LIVING WITH HISTORY

Certificate of Appropriateness

Property	2034 N. 1ST ST. Brewers Hill Historic District
Description of work	Remove existing chain link fence from front of property. Install new wood picket fence in side yard. Install new guardrails and handrails on front porch. Remove light fixtures on fronts of porch posts. Remove substitute siding material from porch and repair or replace wood to match original as needed. Replace tongue and groove wood porch floor on first story with new wood tongue and groove porch flooring. Any deteriorated floor joints on first floor will be replaced. Replace beaded wood porch ceiling as needed to match the original profile and size of wood. Replace second story porch deck as needed and cover with epdm material or metal. Install new porch skirting after removing existing.
Date issued	4/17/2013 PTS ID 86712 COA, porch work

① Front Elevation
NTS

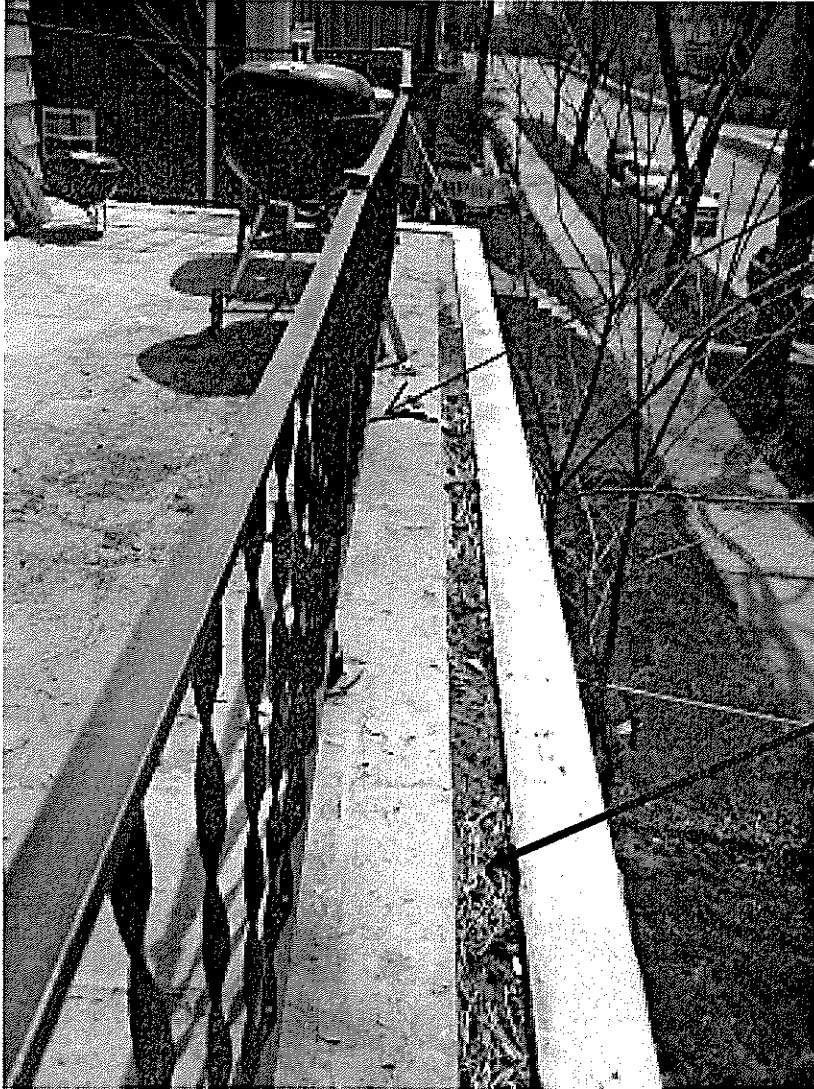
Alum trim to be demolished

Lighting to be demolished.

Chain Link Fence to be demolished.

2034 N. 1st St.
Aluminum/vinyl to be removed from porch structure. Lighting on porch posts to be removed. New guardrails/handrails to be installed.

Chain link fence will be removed and a new wood picket fence will be installed to the side of the house.

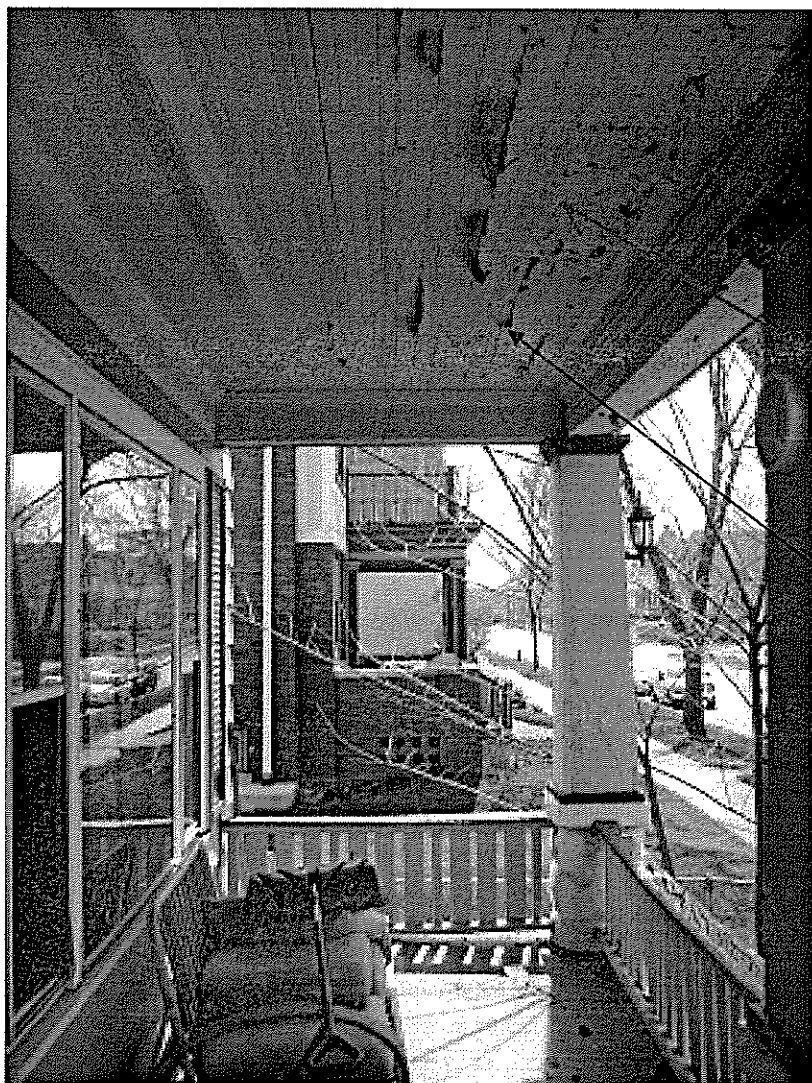
Balcony floor and handrails to be demolished. Rebuild floor as necessary, re roof and rebuild handrail per plans.

Built-in gutter to remain

Porch floor to be demolished and rebuilt per plans.

Porch Ceiling
and trim to be
demolished
and rebuilt to
match
existing.

All wood handrails and skirting to be demolished and rebuilt per plans.

**Porch floor
replacement to be
tongue and groove to
match original**

**Replacement material for
porch ceiling must match
original and must be wood.**

① Stoop and Stair
NTS

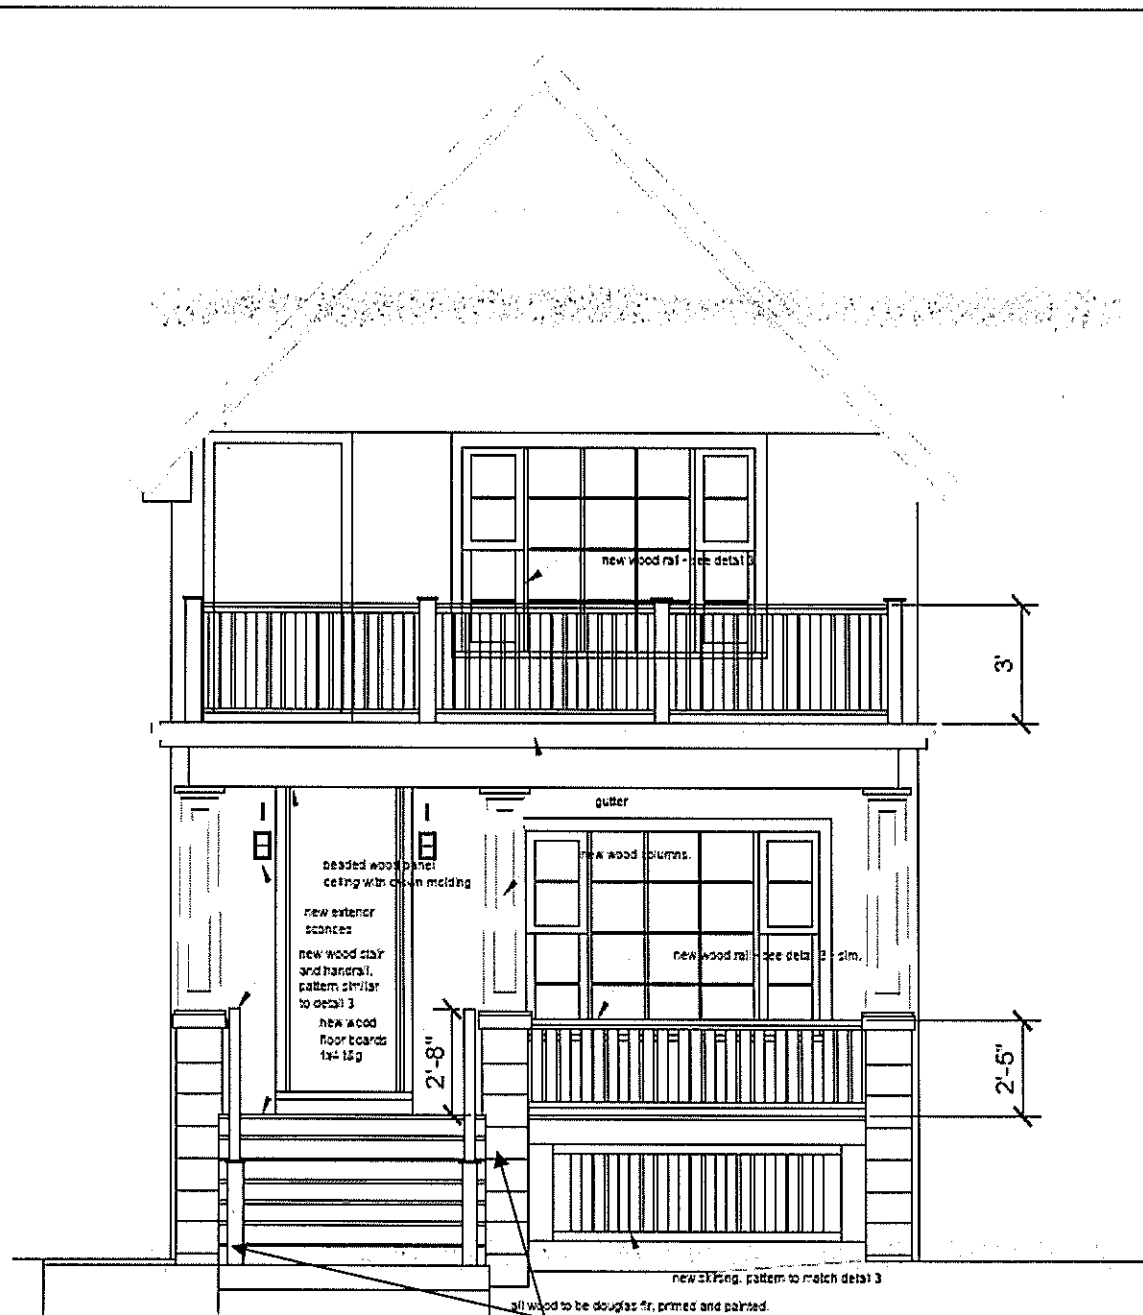
Skirting and railings to be replaced according to attached plans.

Masonry piers
to be stripped
of paint and
tuckpointed as
necessary.

Concrete stair,
stoop and metal
rail to be
demolished.

Concrete piers must be chemically cleaned only. No abrasive or grinding allowed.

② Proposed Elevation
3/8" = 1'-0"

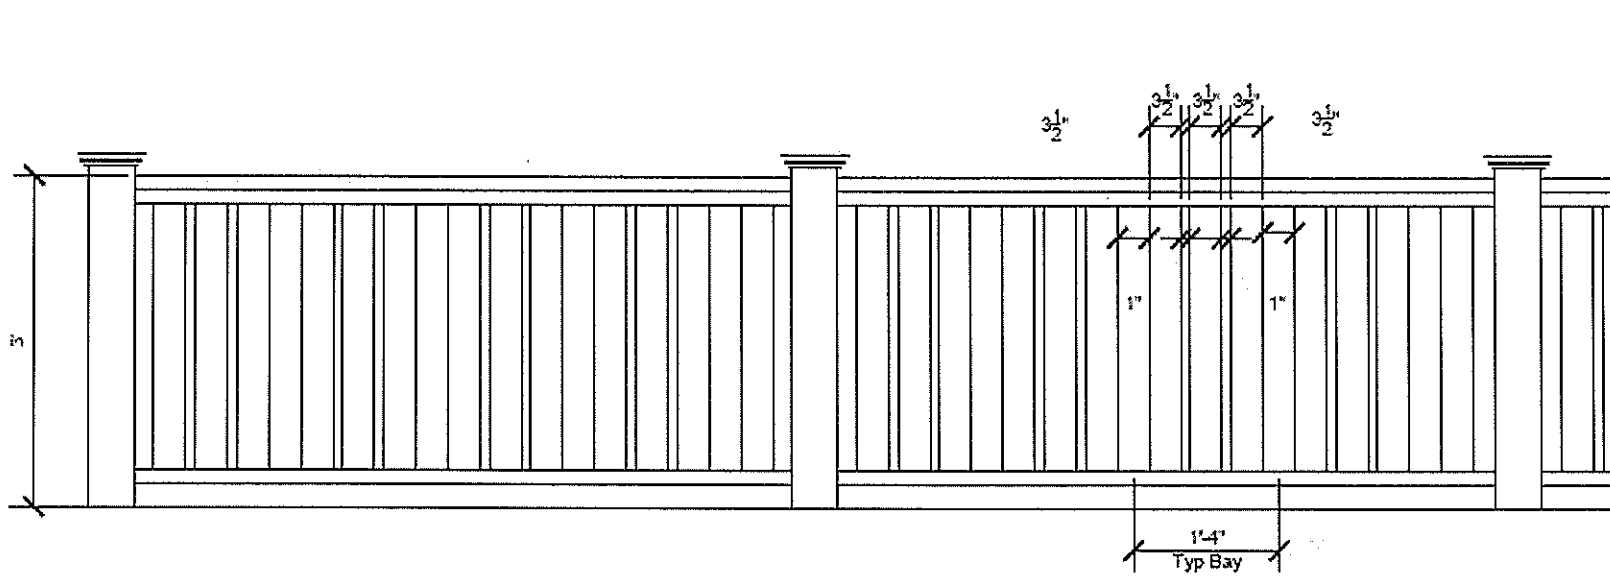
Elevation drawings showing design for new guardrails and skirting and porch posts.

Newel posts on steps to match upper newels in design

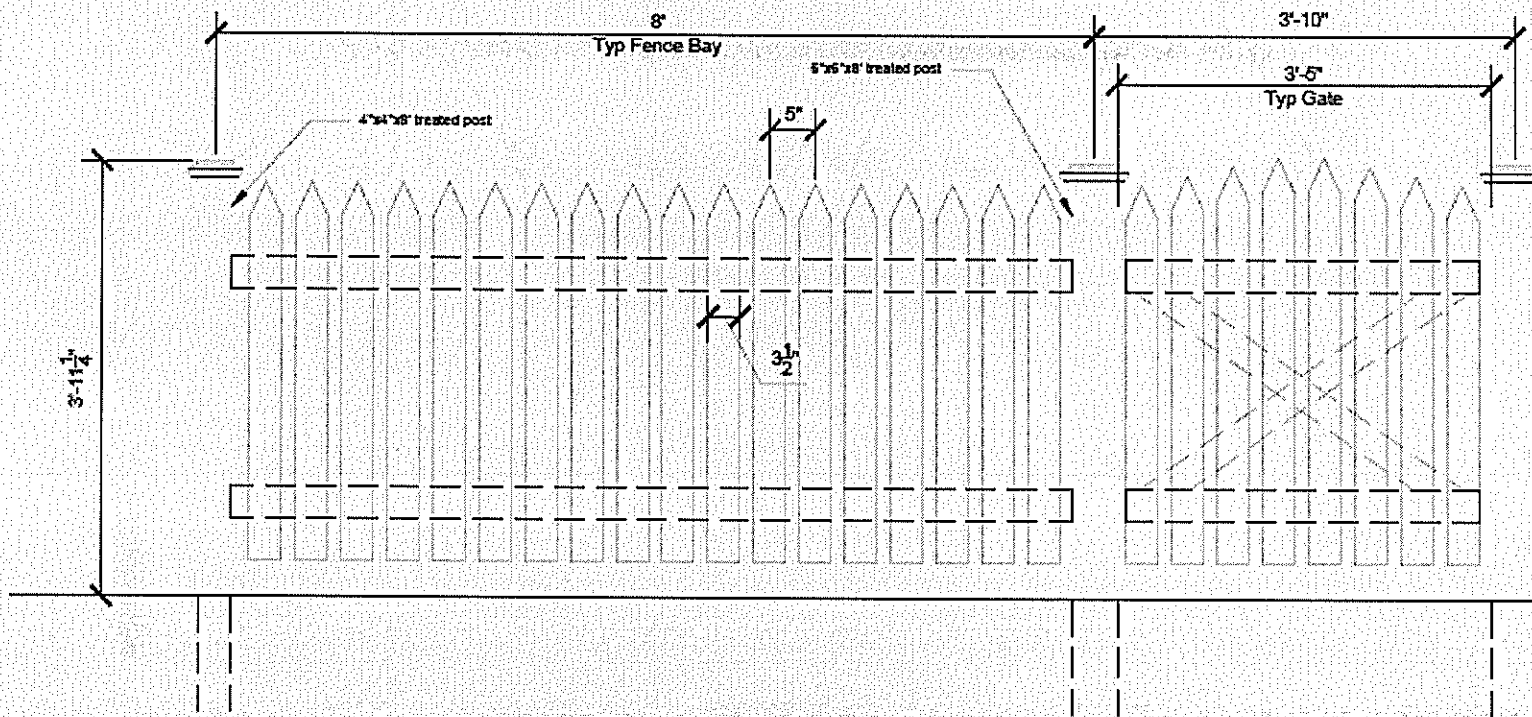
**New wood picket fence to be installed here
on either side of house to the lot lines**

Design of new picket wood fence to replace existing chain link fence at front of property. Fence must be painted or stained upon completion.
